DEVELOPMENT REVIEW BOARD
SUPPLEMENTAL SUBMITTAL

PROJECT NO. 8/21/2020
Application No. PR-2020-004030/ SD-2020-00540

SUBMITTAL DESCRIPTION: Plan Updates and response to comments

TRACT D-1 & E-1 CONCEPT
 PARADISE HEIGHTS, UNIT 1
 ALBUQUERQUE, NEW MEXICO

Wintergreen Luxury Apartments
Golf Course Road
Albuquerque, NM
Conceptual Landscape Plan

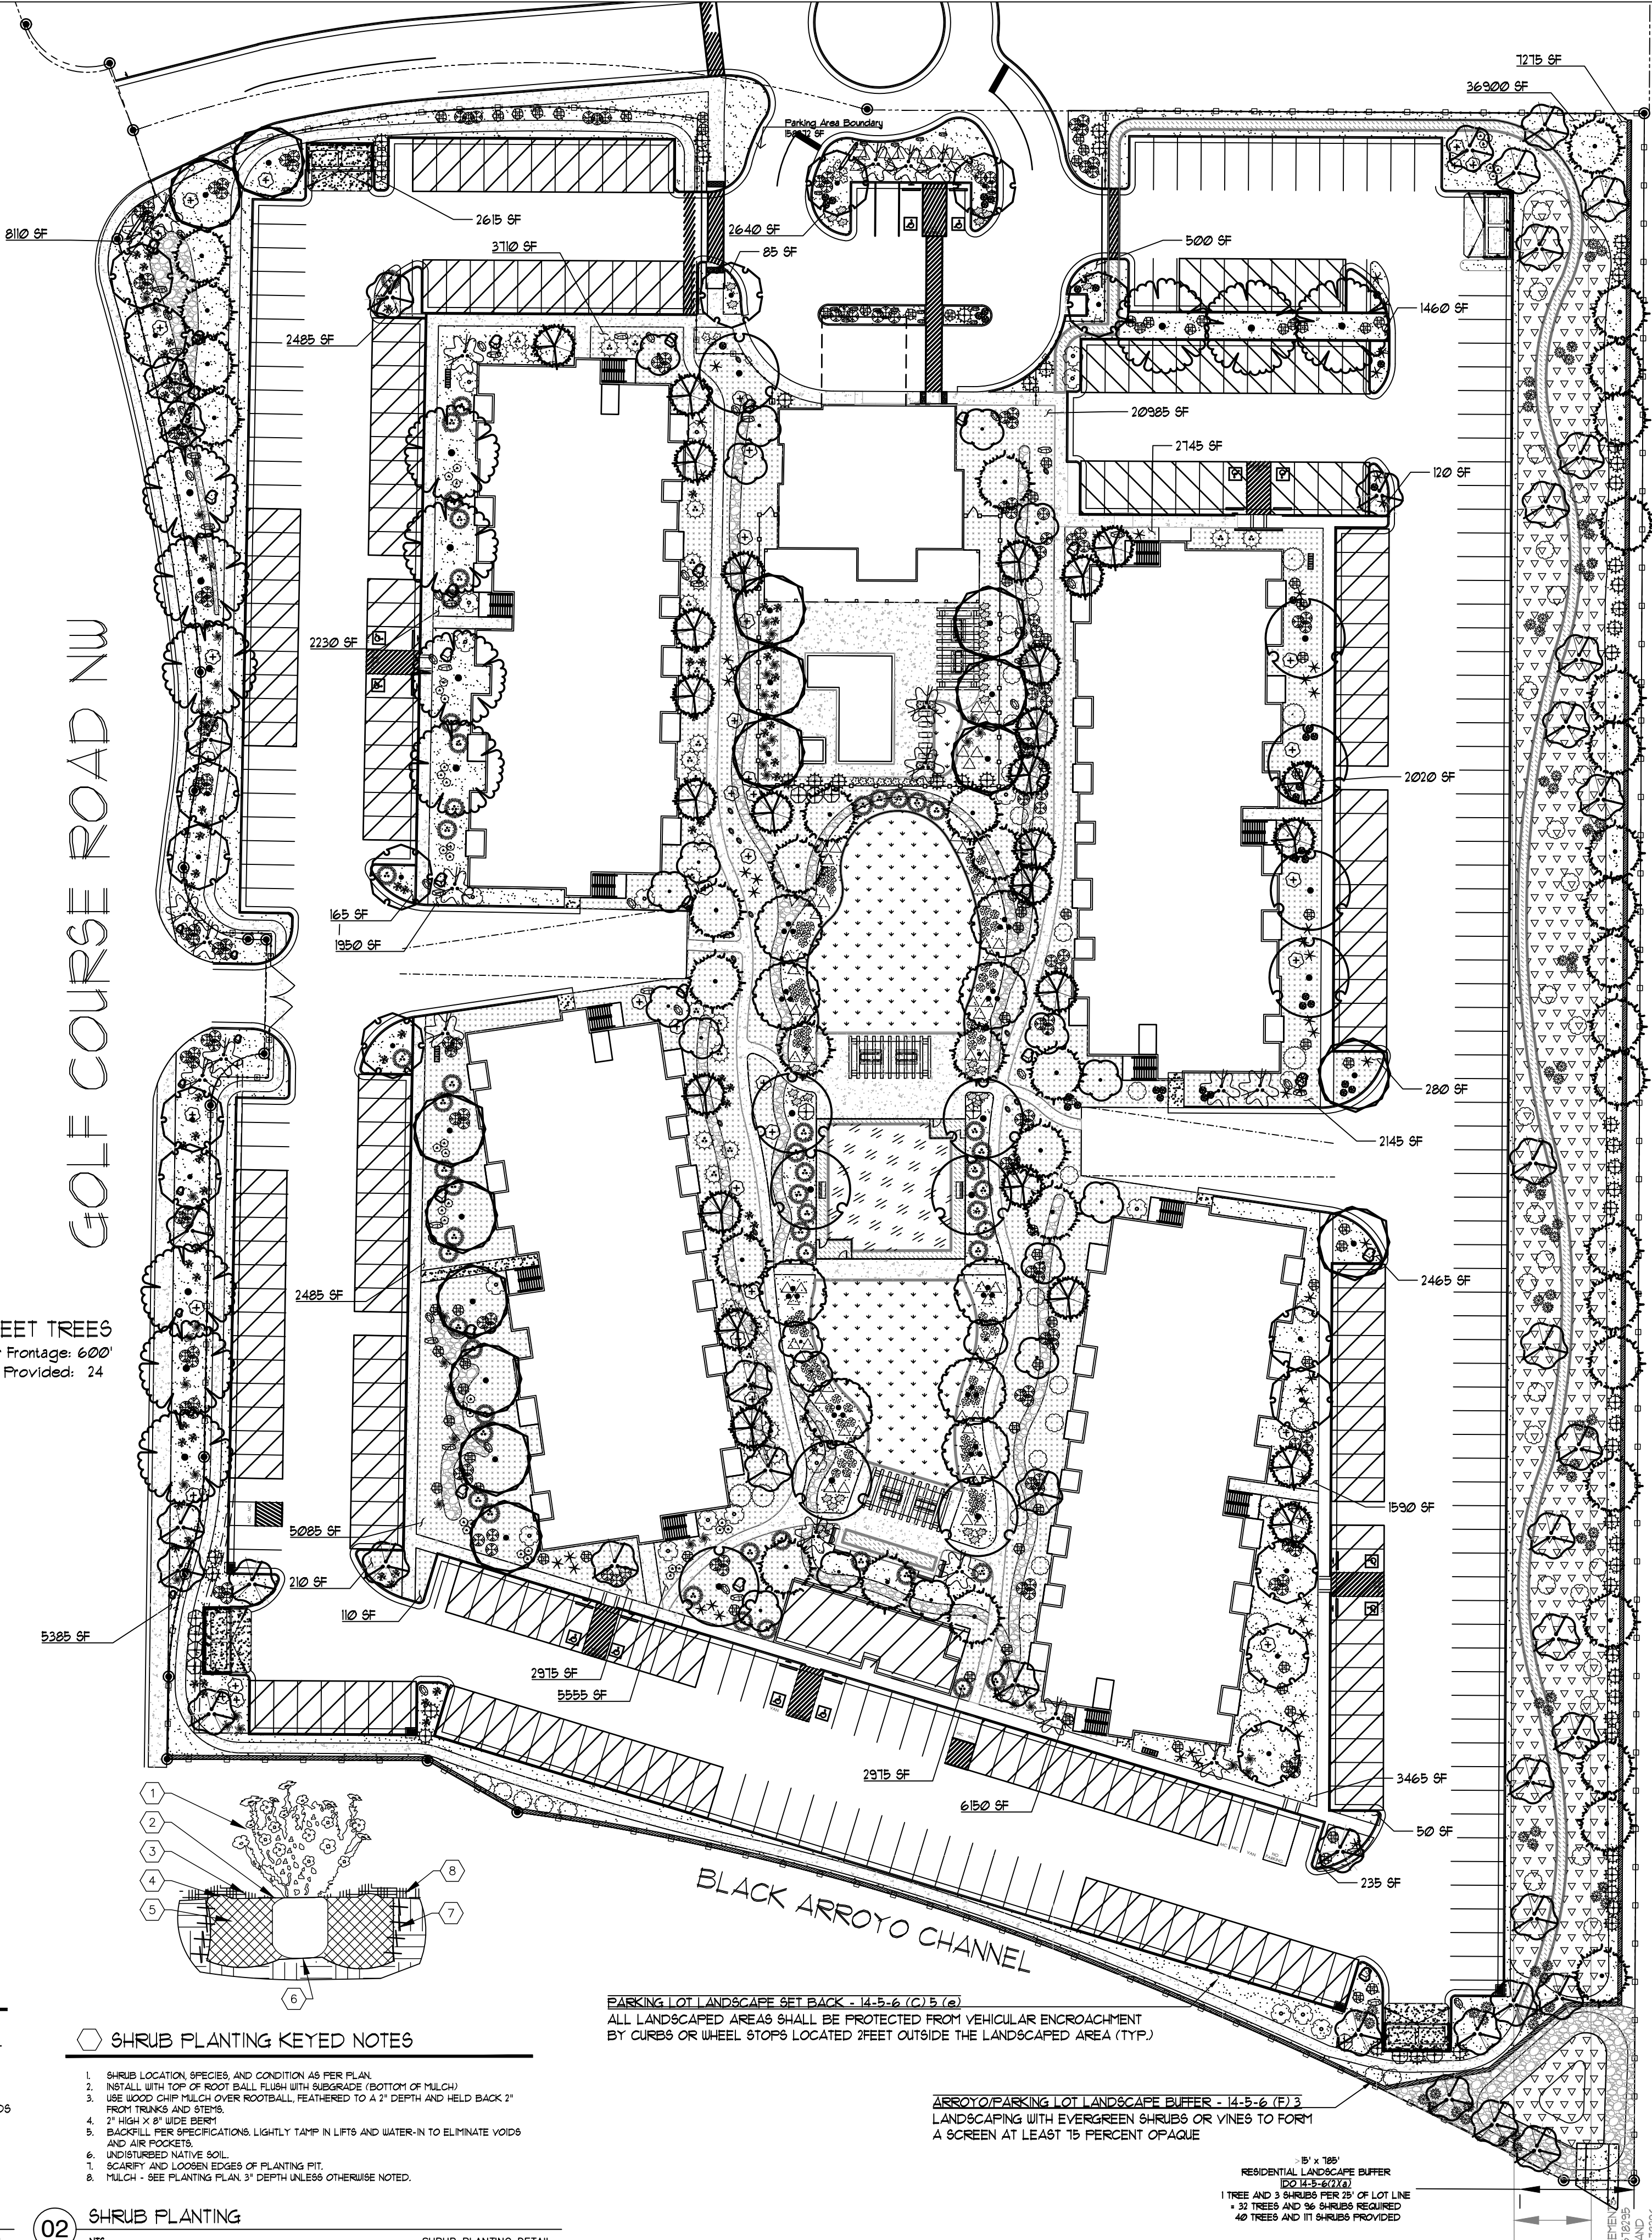
On the south property line, this parcel butts up to the Black Arroyo which drains into Open Space's Calabacillas Arroyo and eventually into the Rio Grande, and there is a concern about flows from the site. Therefore, native plants would be the best choice for landscaping materials. Chinese Pistache (especially females) are invasive and there is a concern about invasives moving down the Black Arroyo to the Calabacillas and Rio.

PRD requests removing Chinese Pistache from the plant list and preferably limiting all plant material to natives. Landscape species should comply with the CABQ Pollen Control Ordinance.

Please review updated landscape plan. Locally-occurring plants were used where possible and a column is added to the plant schedule indicating native status. Also added a number of pinon pines to the planting plan as a source of native evergreen color. Vines have been removed. Tried to keep other planting quantities and locations the same, adjusting for layout where necessary.

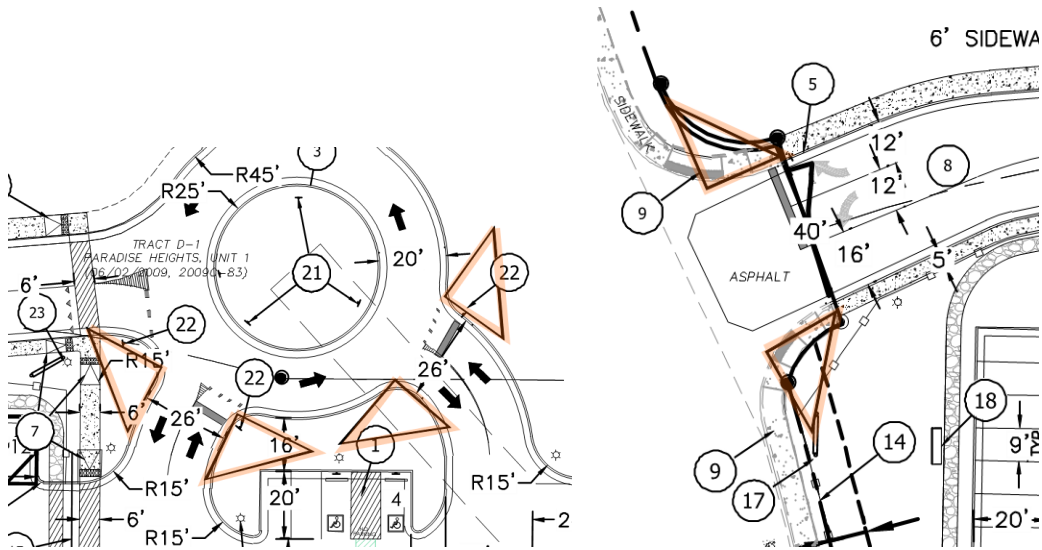
4. Where are the clear sight triangles at access points for both the site plan and the landscaping plan shown under AASHTO guidelines? I could not find these.

Response: They are on the plan, I've highlighted them below on sheet C-1, per DPM standards for driveway

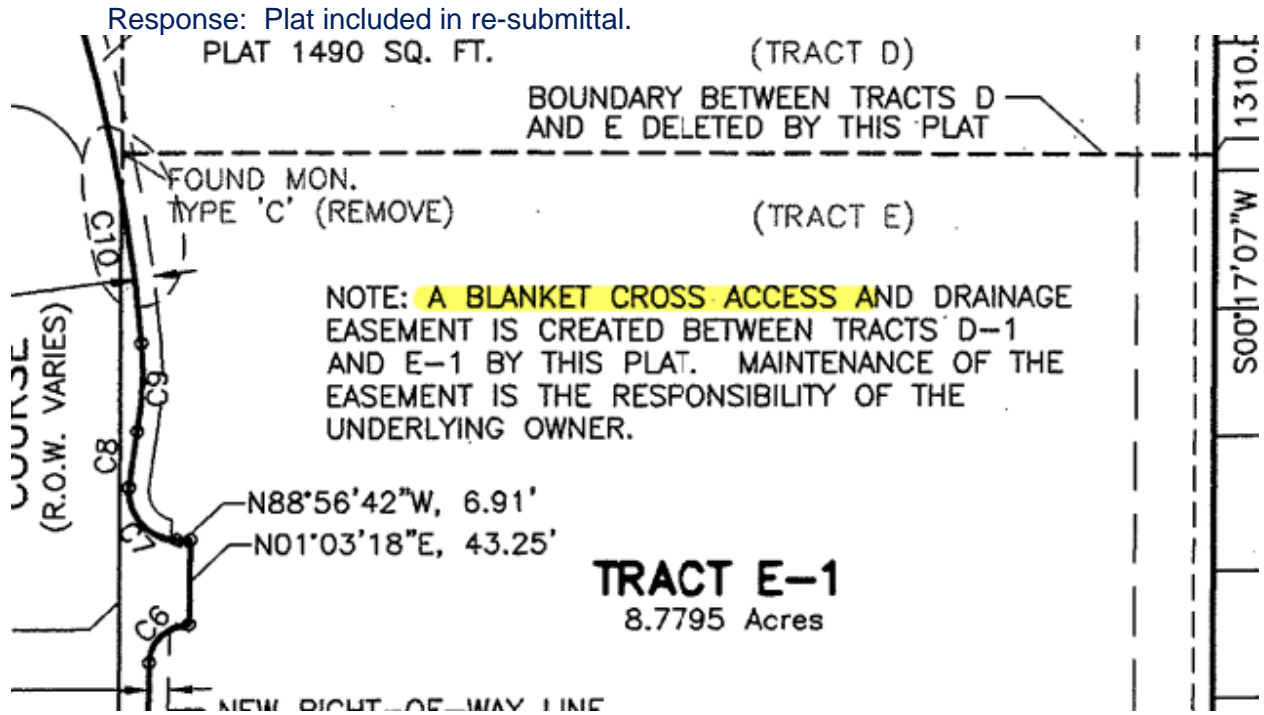
6. The City is requesting public streetlighting on the infrastructure list along frontage. We realize that the old Golf Course Road Improvements did not have them, but this was a separate department that oversees the project, and we don't know the reasoning at the time as to why they were not included. Additionally, traffic has increased since that time.

Response: Added to I.L.
